State of New Mexico
 Energy, Minerals and Natural Resources

Form C-103
 Revised July 18, 2013

7. Lease Name or Unit Agreement Name Scripps	
8. Well Number 4	
9. OGRID Number 330968	
10. Pool name or Wildcat ATOKA; GLORIETA-YESO	
SUNDRY NOTICES AND REPORTS ON WELLS (DO NOT USE THIS FORM FOR PROPOSALS TO DRILL OR TO DEEPEN OR PLUG BACK TO A DIFFERENT RESERVOIR. USE "APPLICATION FOR PERMIT" (FORM C-101) FOR SUCH PROPOSALS.) 1. Type of Well: Oil Well <input checked="" type="checkbox"/> Gas Well <input type="checkbox"/> Other <input type="checkbox"/> 2. Name of Operator SILVERBACK OPERATING II, LLC 3. Address of Operator 19707 West IH 10, Suite 201 San Antonio, TX 78257 4. Well Location Unit Letter M : 660 feet from the South line and 660 feet from the West line Section 25 Township 18S Range 26E NMPM County Eddy 11. Elevation (Show whether DR, RKB, RT, GR, etc.) 3283' GR

Silverback Operating II, LLC plans to plug and abandon this well as follows:

Scripps #4

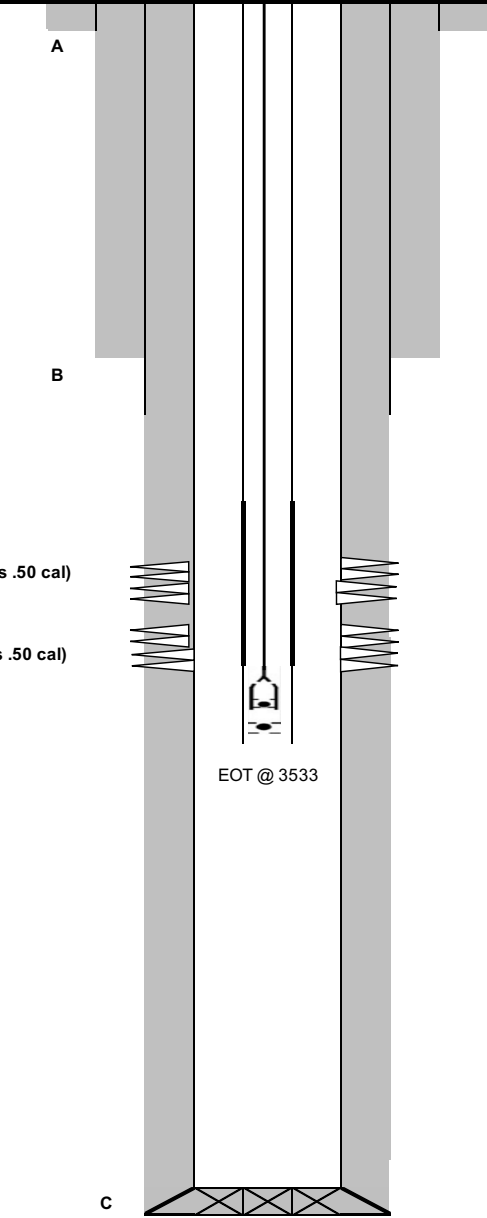
See plugging plan for revisions
 Approval EXPIRES 4/13/2024

1. MIRU workover rig. Load tbg and csg with water as needed. POOH with rods and pump. ND Pumping tee. NU BOP
2. POOH with 2 7/8" tbg
3. GIH with CIBP on tbg and set at 2803'. Spot 25 sk cement plug on CIBP. WOC. Tag cmt plug
4. Perf & Sqz ~~PU and spot 25 sk~~ cmt plug from 804'-1,057
5. PU and spot 25 sk cmt plug from 0-253' Top off all csg annuli
6. Cut off wellhead and install dry hole marker. Clean location as regulated.

Created By	Condition	Condition Date
john.harrison	Perf & Sqz all csg shoes Update WBDs prior to C103-P subsequent submission	4/13/2023
